# TOWN OF NORTH CASTLE

## RPRC RETURN LETTER

Application Number: 2023-0863

Street Location: 99 BYRAM RIDGE RD

Drawing Title:  
**Site Layout Plan**

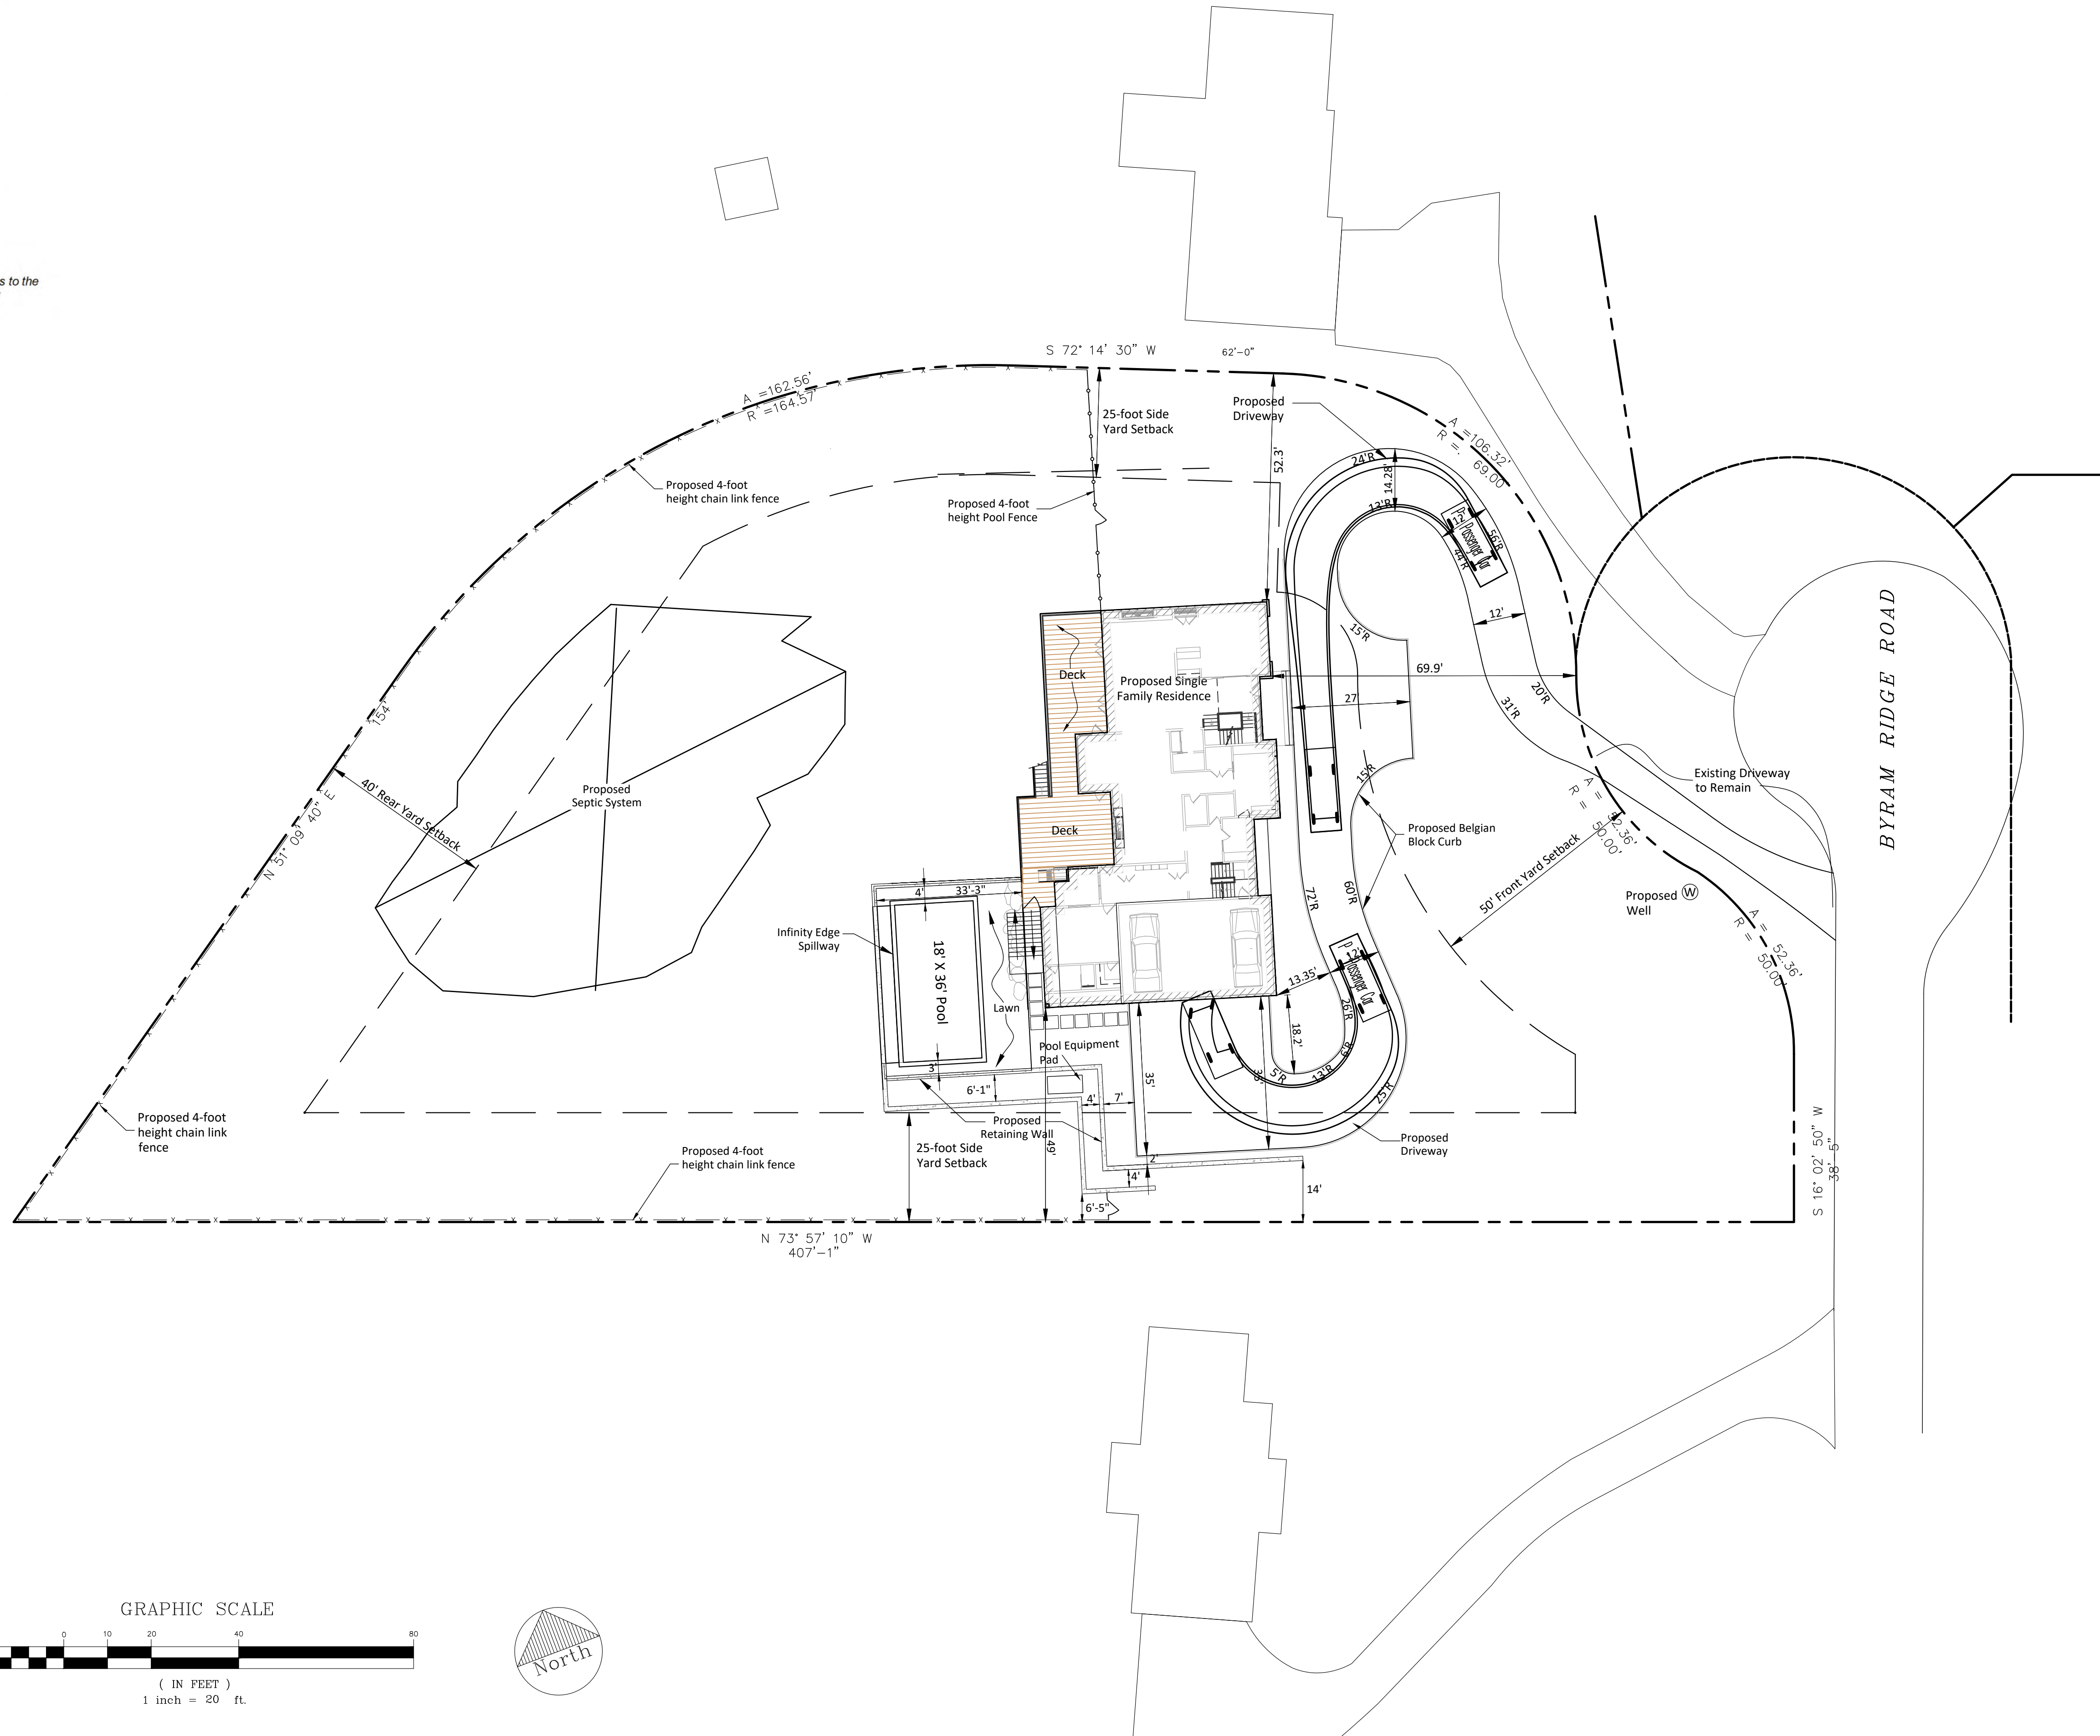
- *The plan shall note that the construction of all walls greater than four (4) feet in height shall be certified by the Design Professional prior to issuance of a Certificate of Occupancy/Completion.*

- *The plan shall include a pool fence and gate detail. The plan shall delineate the limits of each fence type and locate all gates. The plan shall note that the pool fence and gate shall comply with all applicable NYS Building Code requirements.*

Response: So noted. The note has been added to drawing C-101.

Response: The amended plans (see drawing C-101 and C-102) show the location of the proposed pool fence and gates. The pool fence is to extend from the house to the northern property line. The pool fence will also be constructed from a retaining wall to the southern property line. A chain link fence will be constructed along the property line in the side and rear yard as shown. A detail of the proposed pool fence and gate and notes regarding the installation of the fence are on drawing C-113.

**Grading and Utilities Plan**

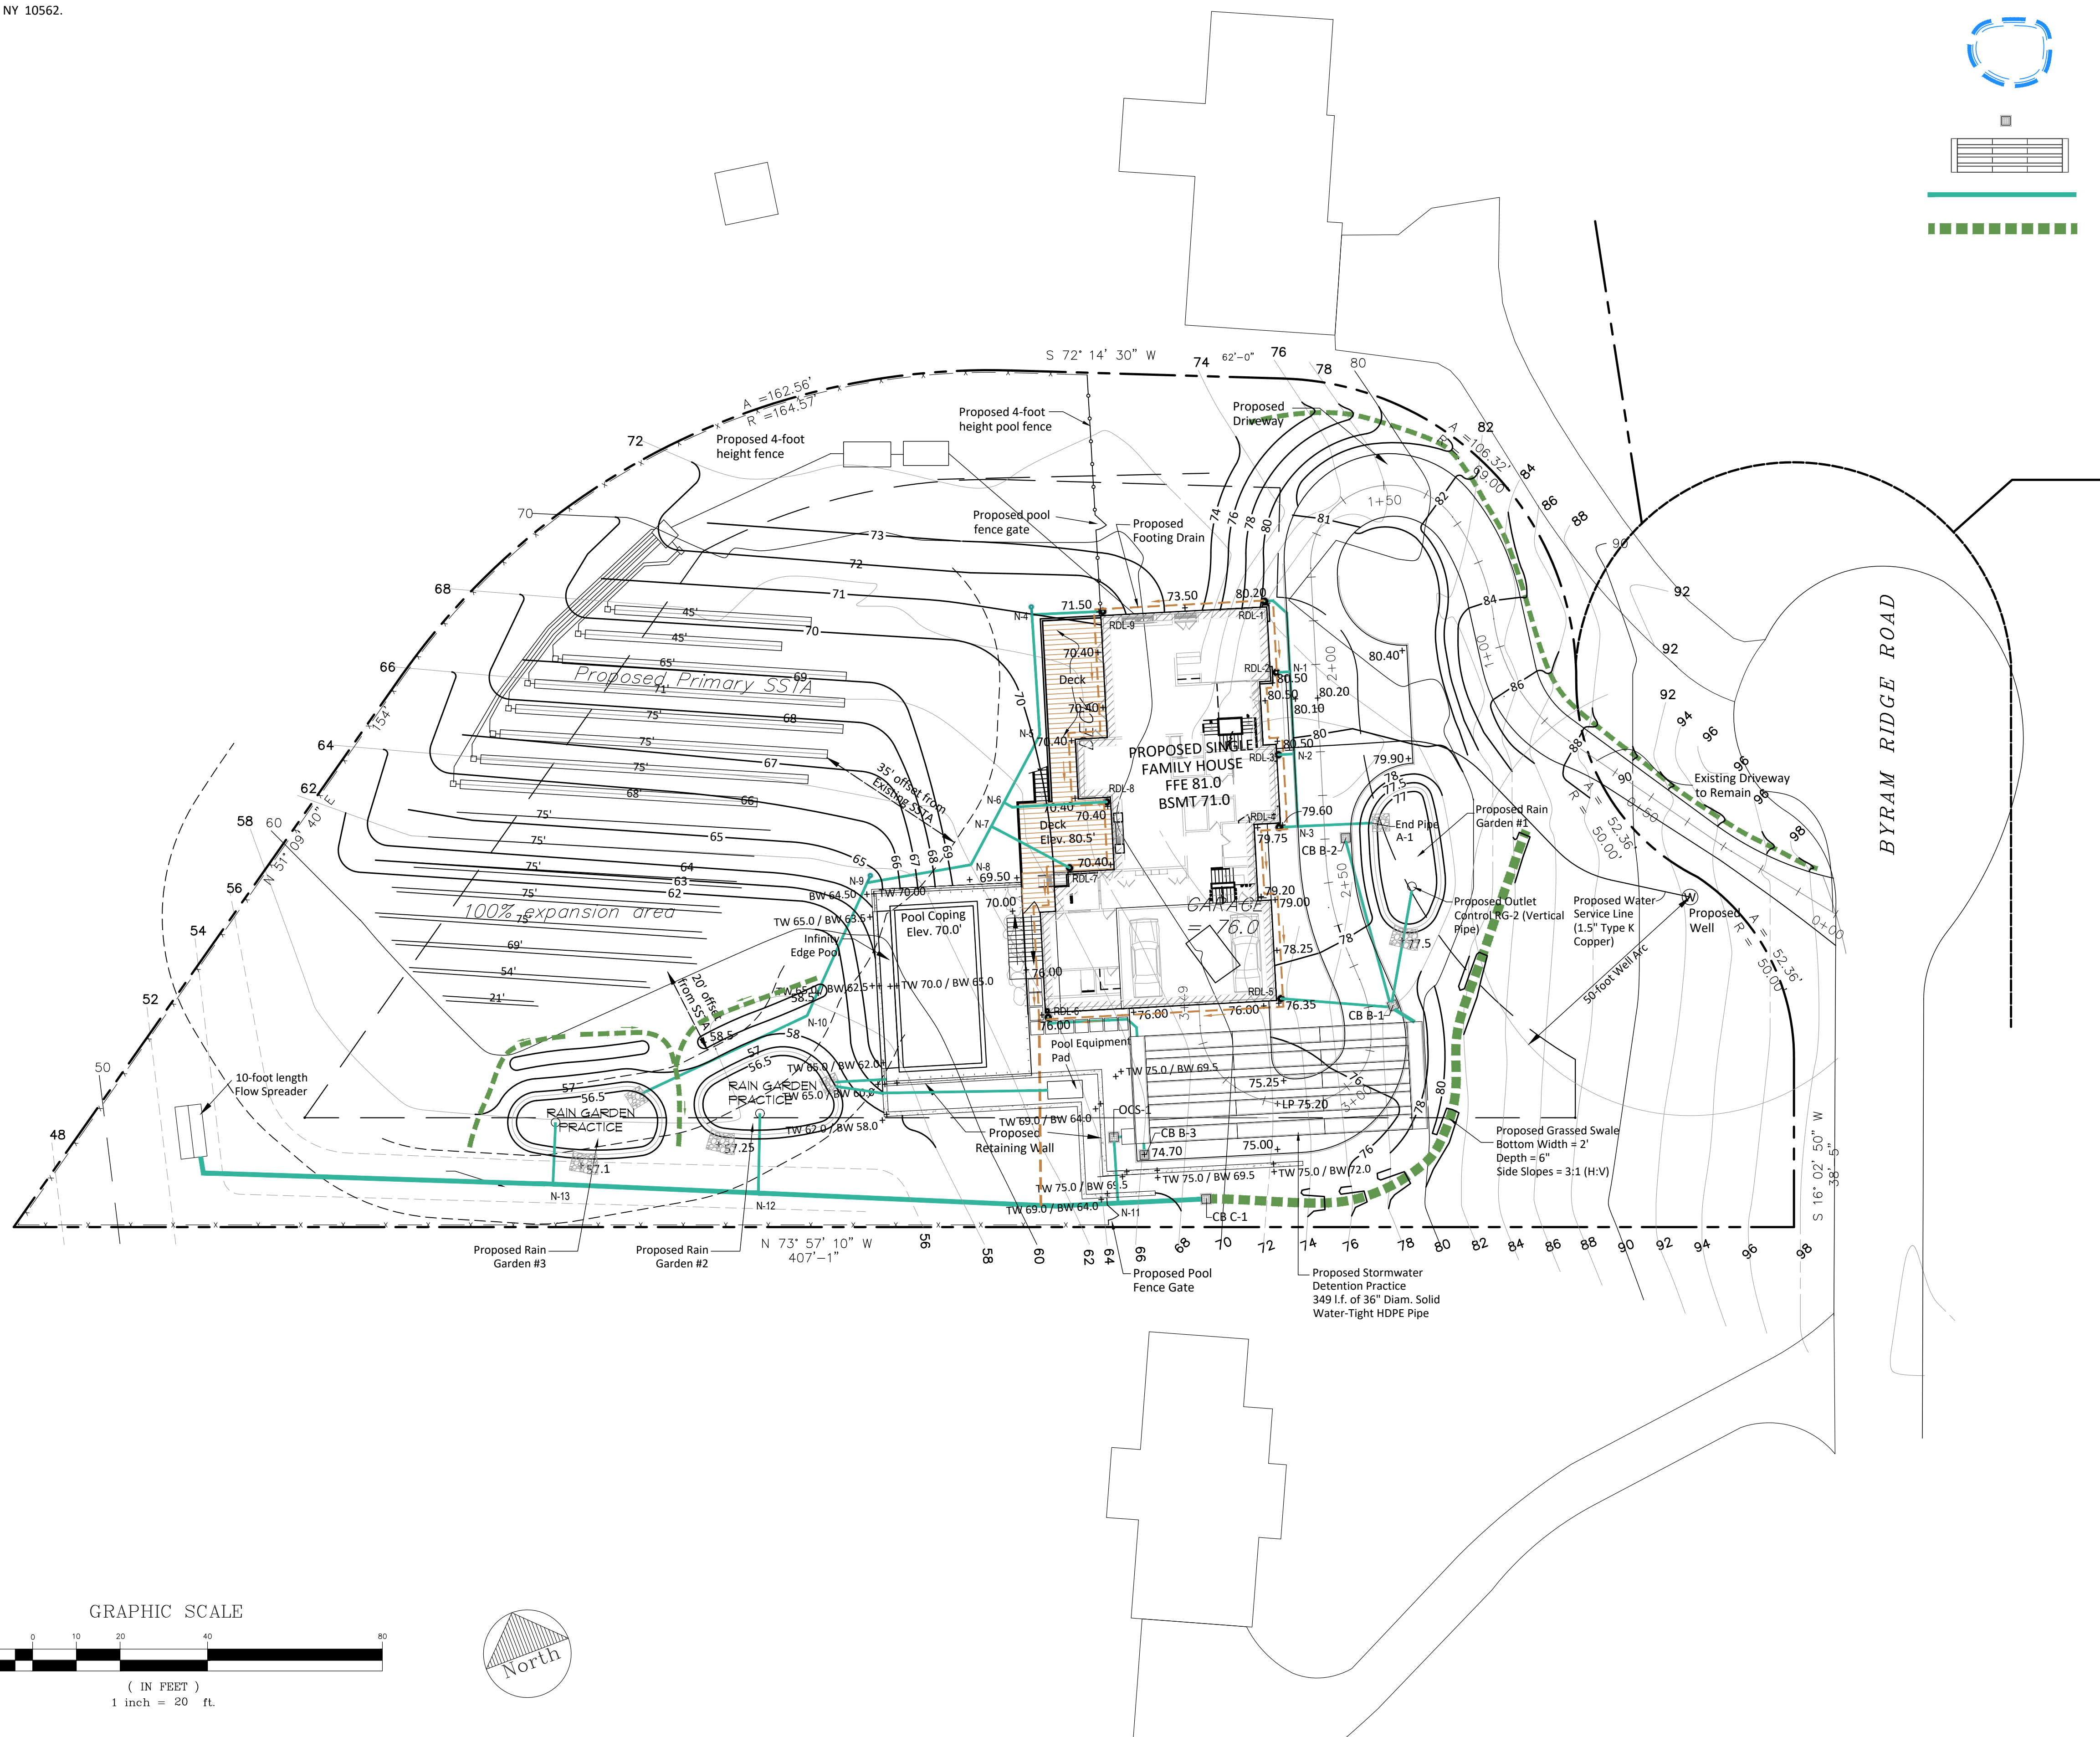
- *The plan shall illustrate the location of the existing or proposed well and the associated service.*

- *Provide rims, inverts, size and material for all drainage facilities. Provide details.*

- *The plan shall illustrate the connection between the pool equipment and drawdown mitigation practice.*

- *The plan shall illustrate the roof drain and drainage pipe connections on the site plan. Include the size, slope and material. Provide outlet protection details.*

- *The plan shall illustrate the footing drain location on the site plan. Include the size, slope and material. Provide outlet protection details.*

Response: The proposed well is shown on drawing C-102, as well as the separation distance from stormwater management practices. The location of the existing well to be abandoned is also shown on drawing C-102.

Response: Rim and invert elevations, and size and material for all drainage facilities is provided on drawing C-102. Details are provided on drawings C-112 and C-113.

Response: The connection between the pool equipment and drawdown mitigation is shown on drawing C-102.

Response: Roof drain leader locations are shown on the revised plans (see drawing C-102). The storm drainage pipe connections of the roof drains to the storm drainage system are also shown on this plan. The table on drawing C-102 shows the size and slope of the pipes from

the roof drain leaders. See drawing C-111 for the outlet protection (rip rap apron – energy dissipator) detail. The notes on drawing C-102 provide the type of material for the storm drainage pipe and water service from the well into the house.

Response: The proposed footing drain pipes are depicted on the submitted plans (see drawing C-102). Footing drains are to consist of 4” diameter PVC pipes.
